CITY OF CORCORAN
Corcoran Planning Commission Agenda
August 6, 2020 - 7:00 pm

RE: **PUBLIC HEARING.** Nelson International Conditional Use Permit, Site Plan and Variance for the property at 10409 County Road 101 (PID 01-119-23-41-0001) (city file no. 20-022)

Subject: Nelson International – Plan Review Comments

Exterior Elevations

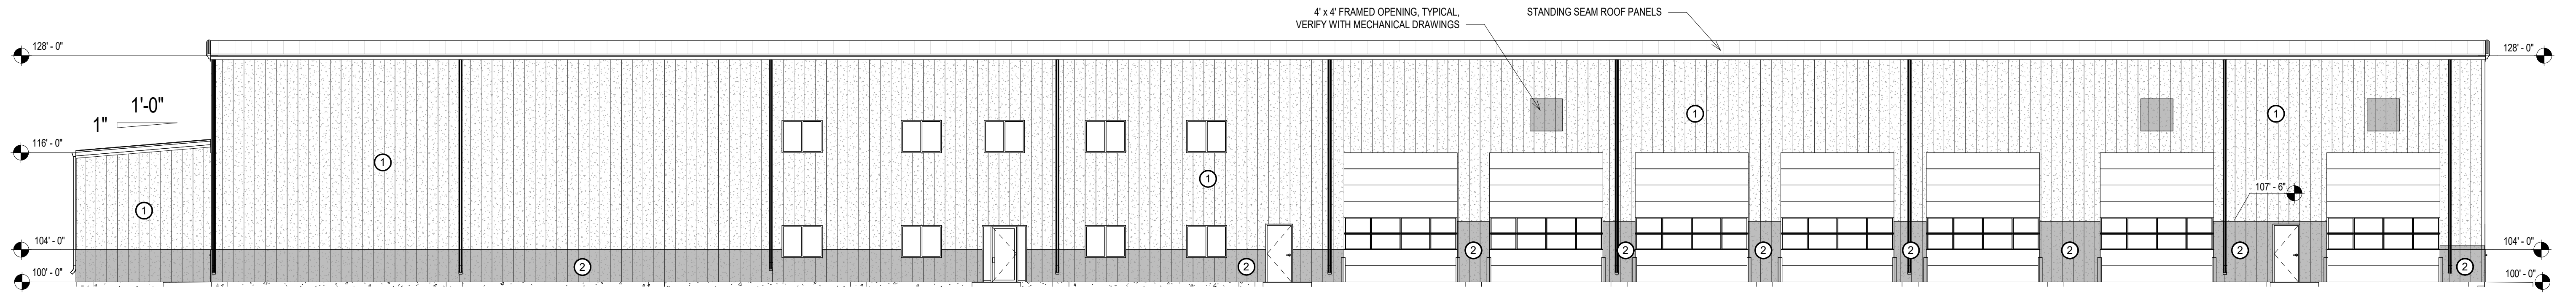
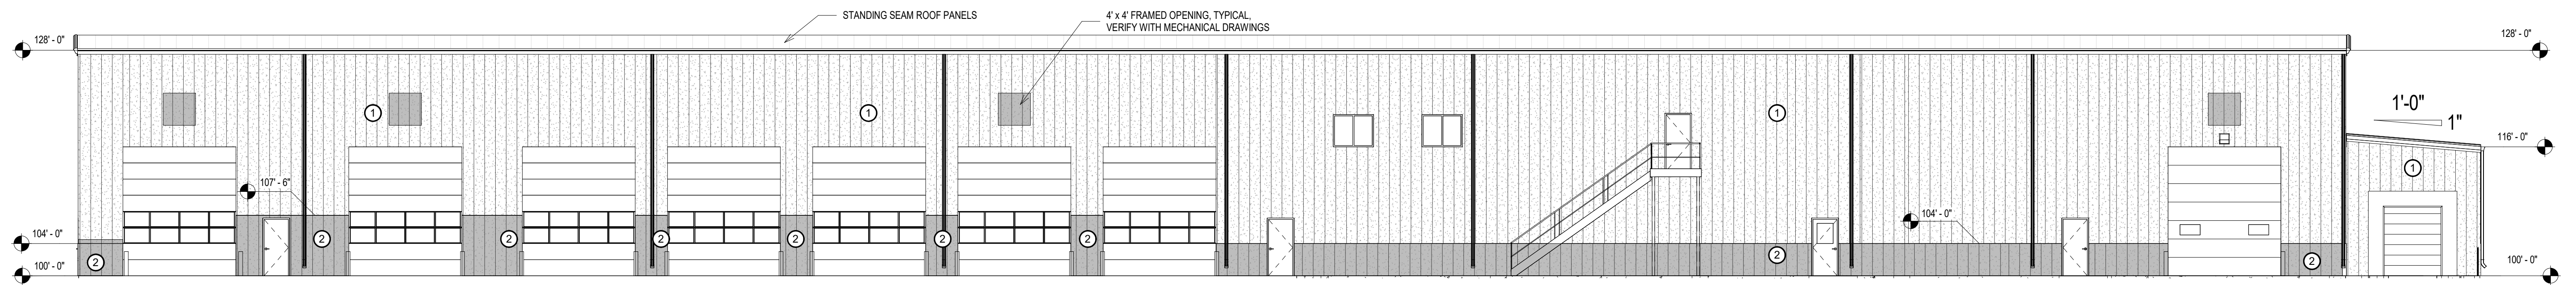
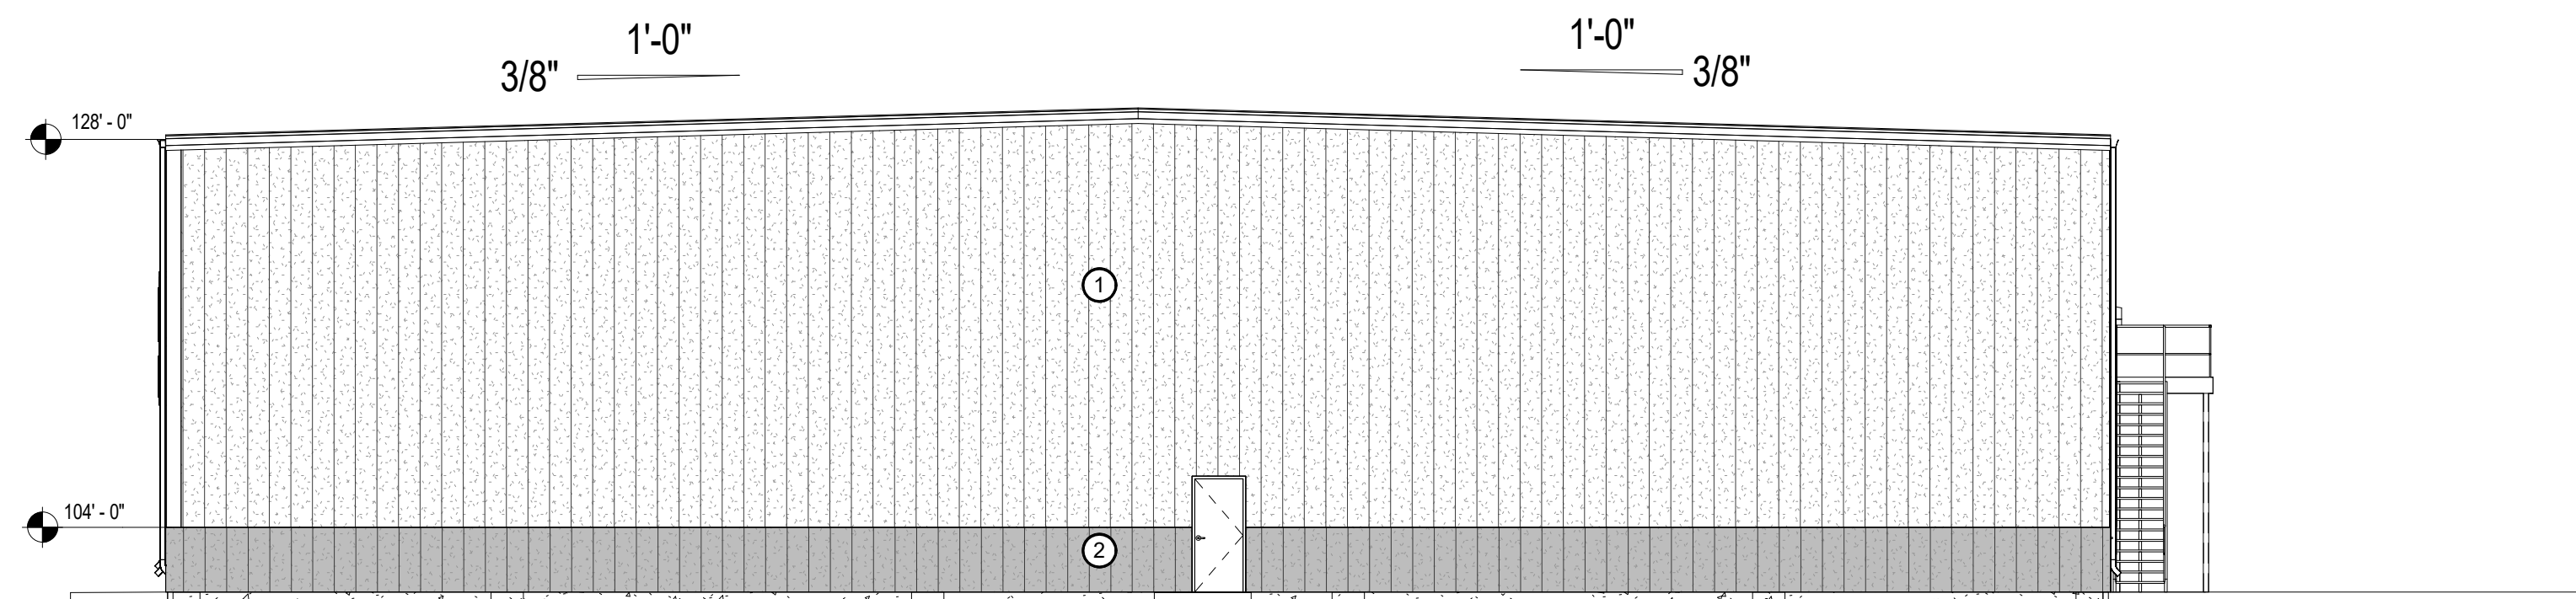
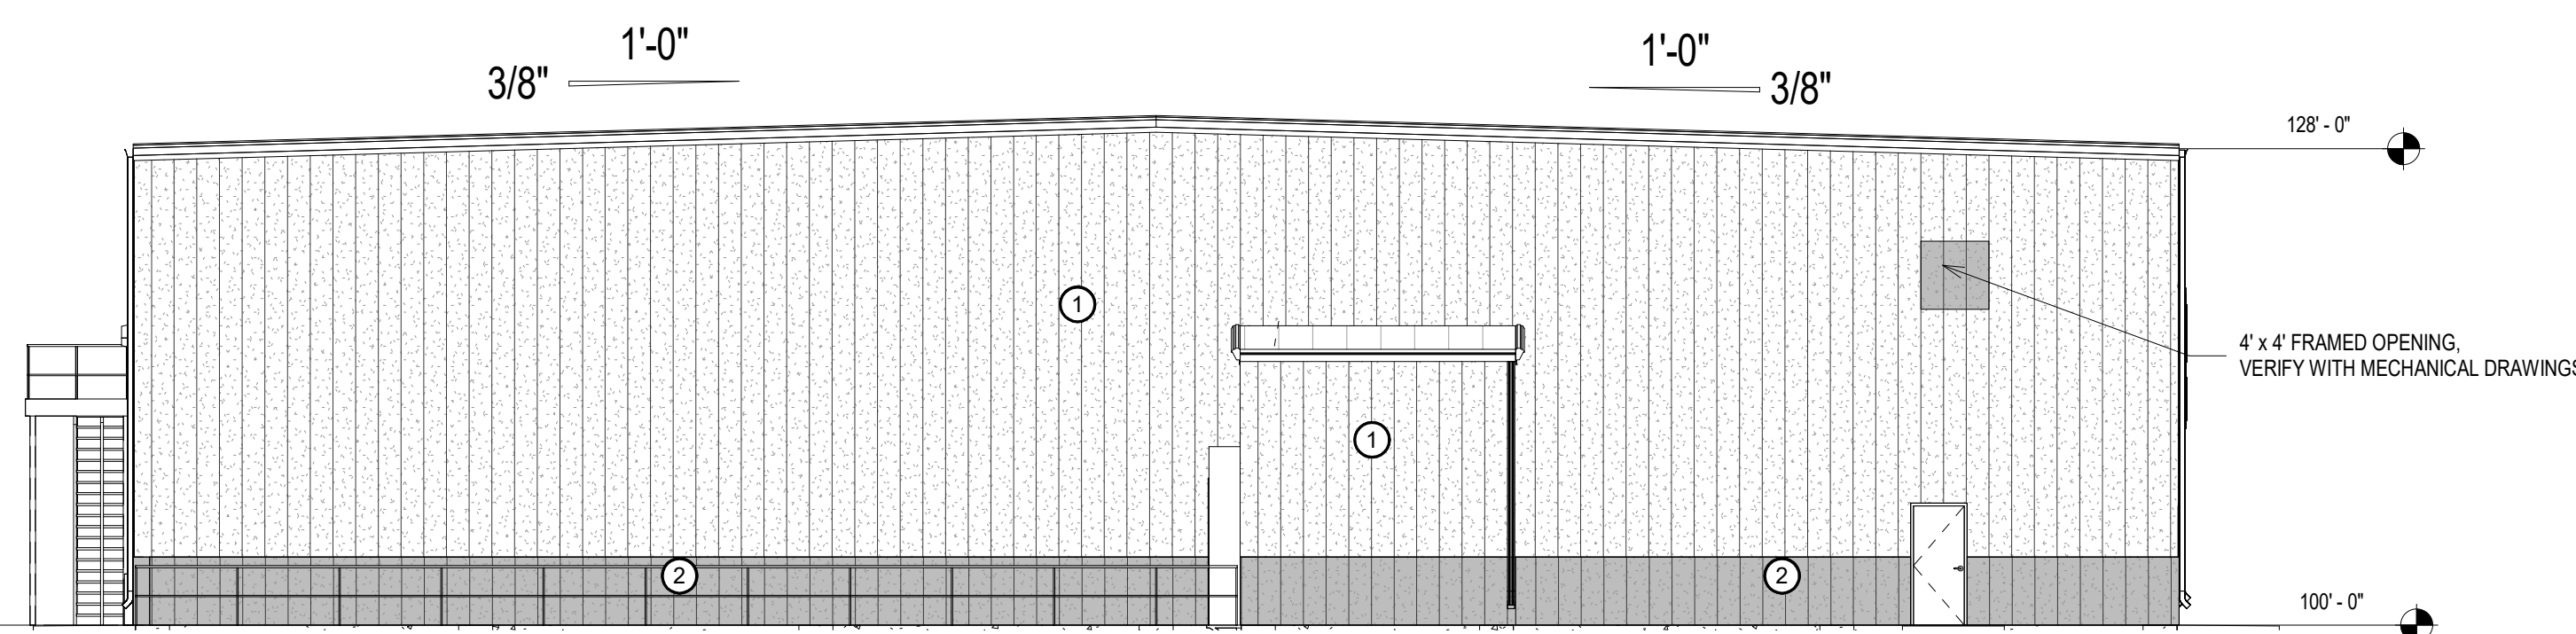
Architectural elevations were submitted showing a mix of glass, EIFS material and TextureClad, an architectural metal panel that is finished to look like stucco. The building is a plain rectangle with no articulation provided by either physical or color/texture changes to the building. Staff has included a condition requiring the applicant to revise the plans to provide more visual interest, which could be done with color and material changes rather than a physical change to the building.

6. The building plans should be revised to comply with the building material standards in Section 1060.050 and the architectural standards in Appendix A of the Zoning Ordinance.

SIGN 6

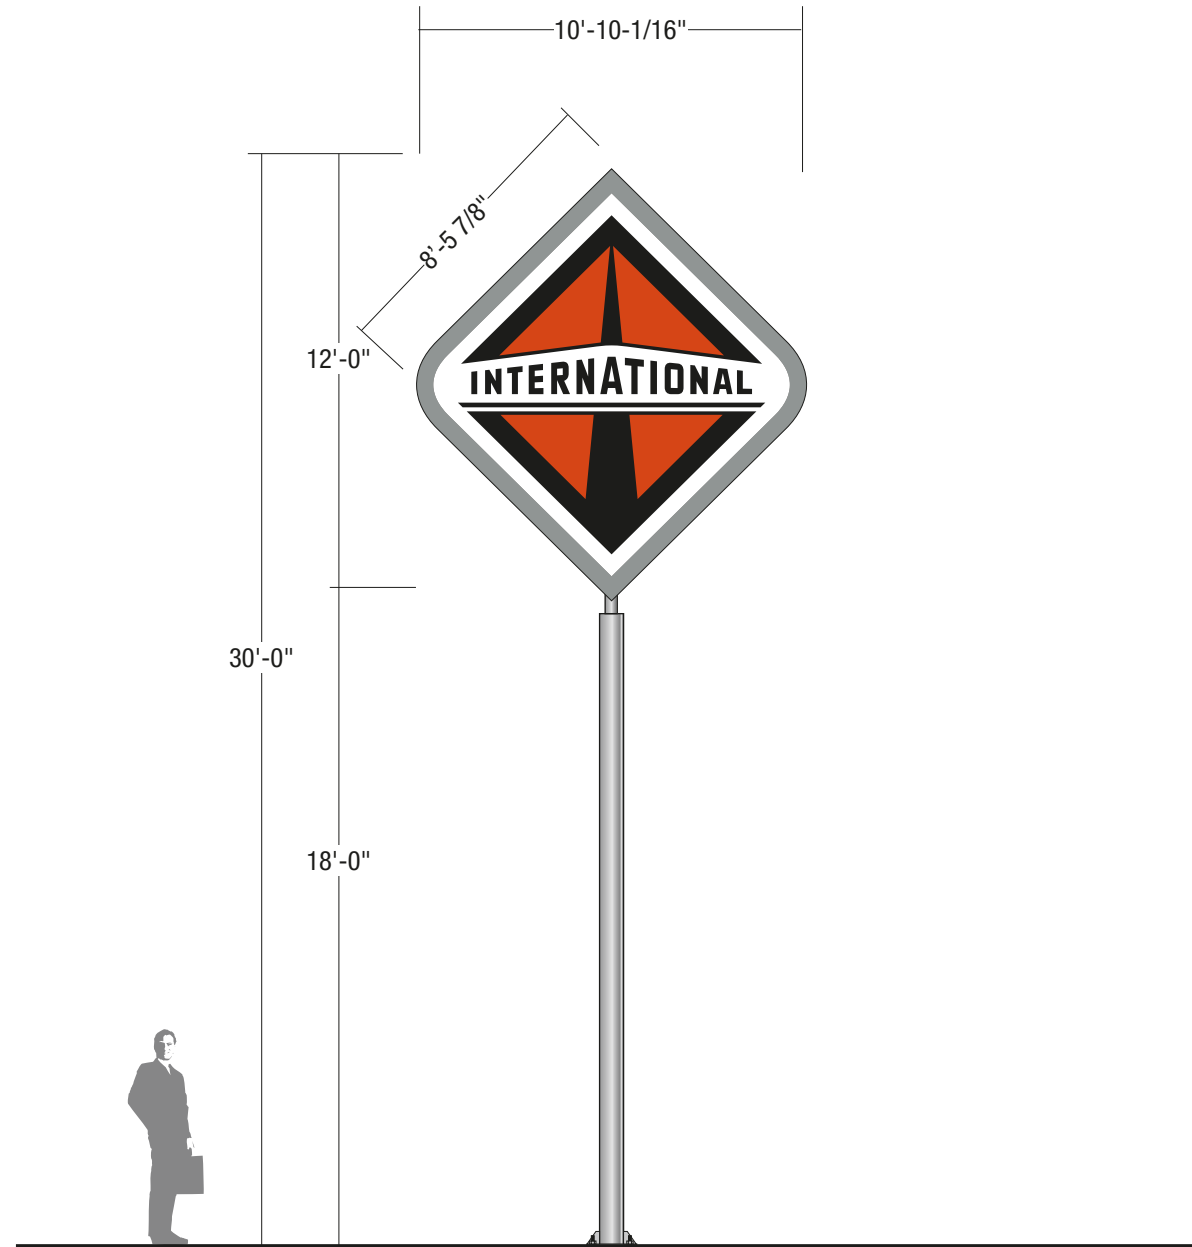
The freestanding sign (sign 6) along County Road No. 101 exceeds the limitations of the code. The sign is 130 sq. ft. in area where 64 sq. ft. is permitted and is 30 ft. high where 16 ft. is allowed. The plans must be revised to comply with the ordinance standards. The applicant should also consider shifting the freestanding sign to the west. Currently there could be conflict between the proposed watermain and the freestanding sign. Staff also expects that as the County expands County Road 101 in the future, the County would take approximately 30 ft. for right-of-way. The applicant should plan for this future expansion to ensure the sign does not end up in the right-of-way.

10. The sign plan must be revised to comply with Chapter 84 of the City Code. No variances are granted or implied.
 - a. The freestanding sign must be revised to comply with area and height requirements.
